# Access Compliance Report

### (Curb Ramps)

Intersection ID: 24930	Main Street: KING_EIDER_DR	Cross Street: CHOATE_CR	Location: NE
ADA ID: B6DB1FC31B80	Ramp Type: PerpDiag	Initial Pass/Fail: Fail	Overall Compliance: No
			Severity Score: 13.75

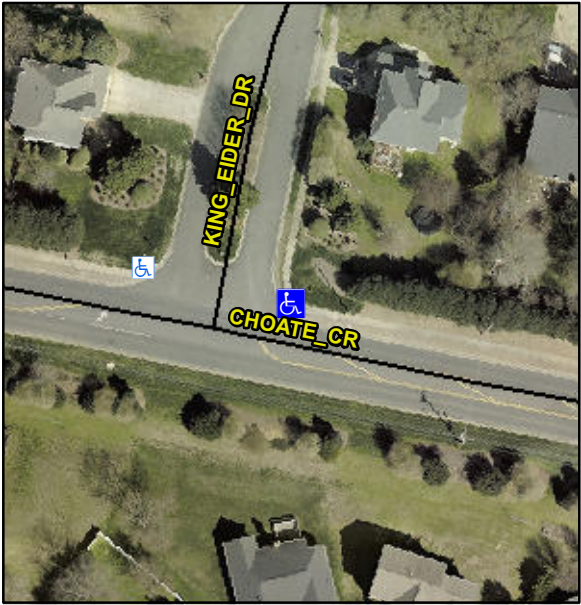
Codes/Mitigation Info/Possible Solution			Field Measurements/Component Compliance		
	Possible Solutions:		<b>Compliance</b>	<b>Description</b>	<b>Data</b>
	<b>Remove &amp; Replace Curb Ramp With Two New Directional Ramps or Equivalent.</b>		<b>No</b>	Ramp Length (in)	<b>57.0</b>
			<b>Yes</b>	Ramp Width (in)	<b>48.0</b>
			<b>N/A</b>	Flare Type LT	<b>N/A</b>
			<b>N/A</b>	Flare Slope LT (%)	<b>N/A</b>
			<b>N/A</b>	Flare Traversable LT?	<b>N/A</b>
			<b>N/A</b>	Landing Length (in)	<b>N/A</b>
			<b>N/A</b>	Landing Width (in)	<b>N/A</b>
			<b>N/A</b>	Landing Slope (%)	<b>N/A</b>
			<b>N/A</b>	Landing X Slope (%)	<b>N/A</b>
<p>Surveyor Notes:</p> <p><b>N/A</b></p> <p>PROW/ADA:</p> <p><b>Not Found, R304.2.2, R304.5.3</b></p>			<b>N/A</b>	Flare Type RT	<b>N/A</b>
			<b>N/A</b>	Flare Slope RT (%)	<b>N/A</b>
			<b>N/A</b>	Flare Traversable RT?	<b>N/A</b>
			<b>N/A</b>	DWS Provided?	<b>N/A</b>
			<b>N/A</b>	DWS Contrast?	<b>N/A</b>
